RE: CRIST ELECTRIC GENERATING PLANT  
BIOMASS PROJECT  
PERMIT No: 0330045-001-AV

**BIOMASS WORKSHEET**

Re: **Request for Additional Information**  
Project No. 0330045-004-AC  
Crist Units 4 and 5, Biomass Project

# FIGURE 11: NO<sub>x</sub> VS O<sub>2</sub>

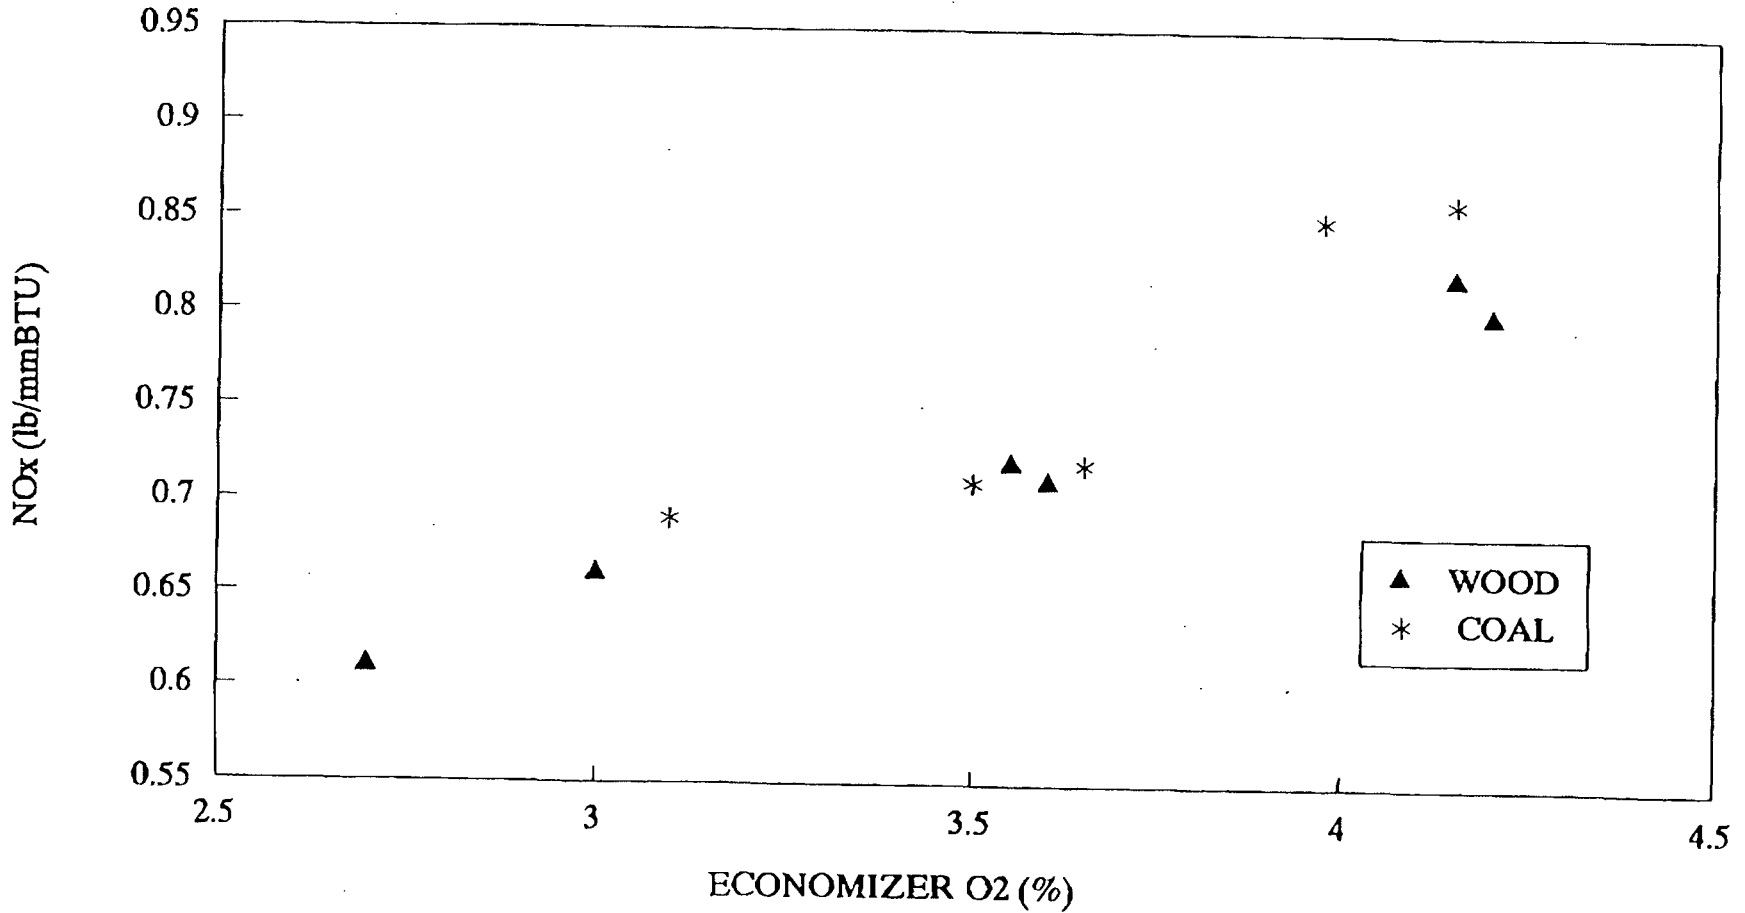
Answer 1c. The potential for NO<sub>x</sub> reduction is solely based on the amount of fuel bound nitrogen. Wood chips and other biomass contain less nitrogen per mmbtu (heat input value) than coal. The data suggest nitrogen oxides may be reduced by up to 9.5% based on the amount of fuel bound nitrogen in biomass. A conservative number is 3-5 % reduction. Carbon monoxide is not expected to increase from the use of biomass because of the small amounts (<10%) and due to the overall design of a coal fired boiler

Only a small or no reduction in NO<sub>x</sub> was measured during wood cofiring compared with coal. Figure 11 shows a plot of NO<sub>x</sub>/MMBTU as a function of O<sub>2</sub>. As expected, NO<sub>x</sub> increases with increasing excess air. The curve suggests that NO<sub>x</sub> may be slightly lower with wood cofiring for the same O<sub>2</sub> level, but this difference is probably within data scatter. It can be concluded that for constant O<sub>2</sub>, NO<sub>x</sub> is not increased with wood cofiring.

FIGURE 12: CO VS O2  
PLANT HAMMOND - 6/92

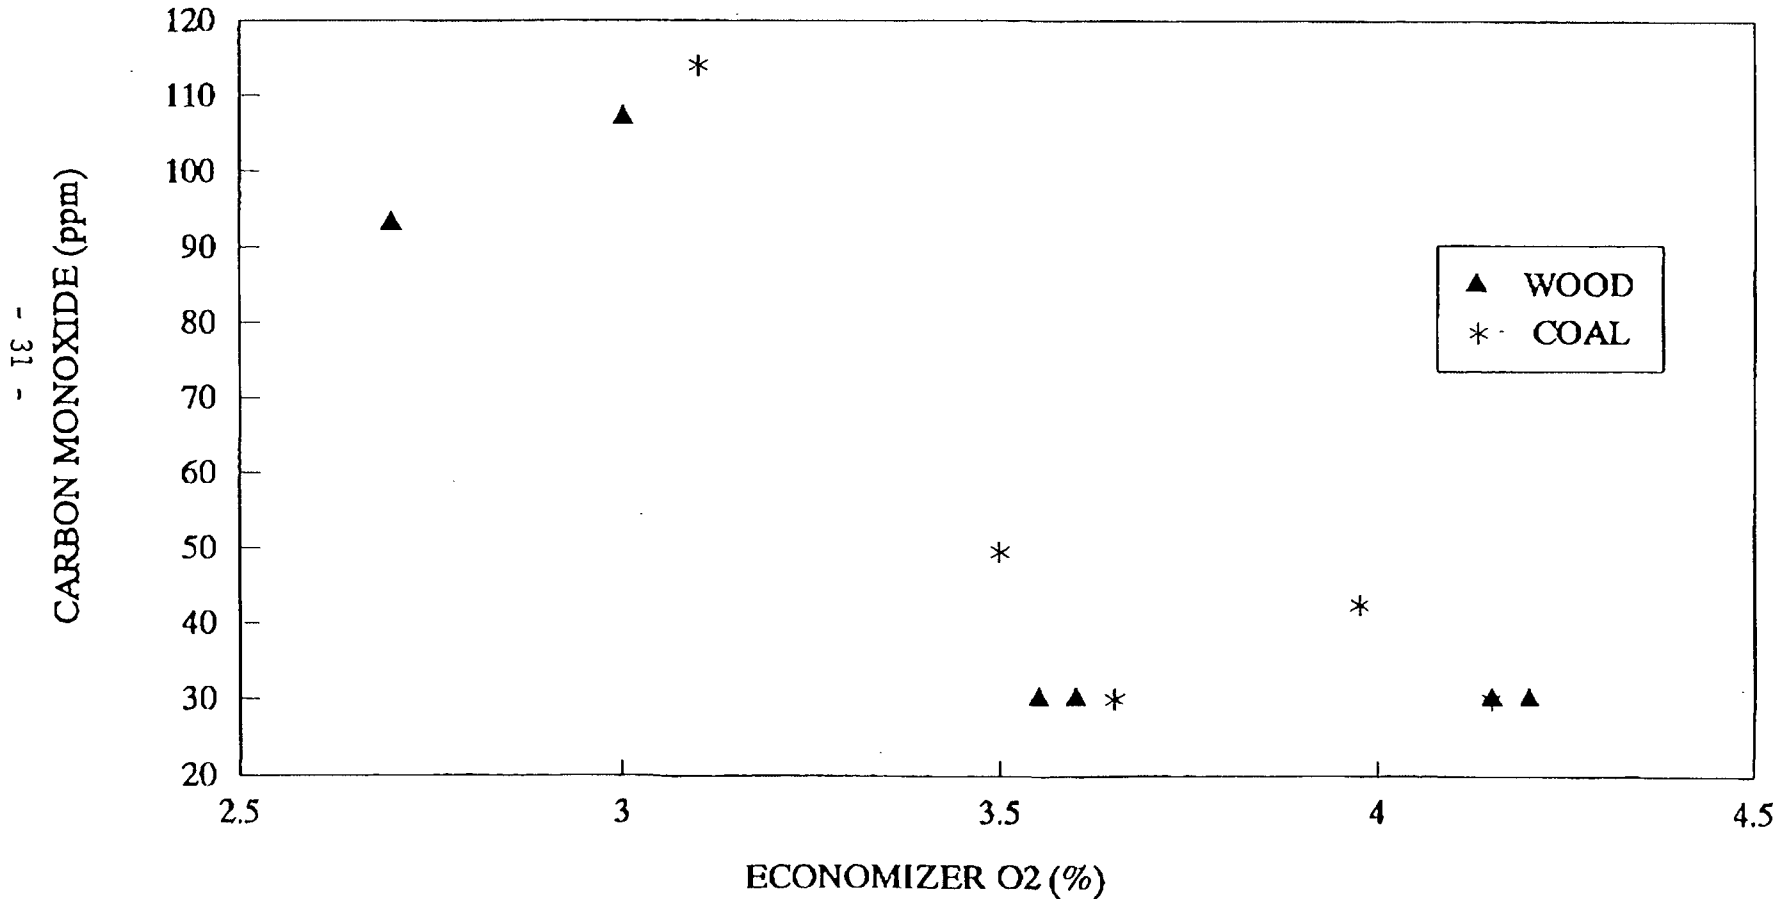
Carbon monoxide measurements were made to determine air settings for the two fuels for the lowest excess air condition. For the low O<sub>2</sub> test, O<sub>2</sub> levels were gradually reduced until CO began to increase. The CO results are plotted in Figure 12 as a function of O<sub>2</sub>. As expected, higher CO levels are experienced at low excess air levels. The curves show that for constant O<sub>2</sub>, within the range of data scatter, approximately no difference in CO emissions was observed between coal alone and wood cofiring.
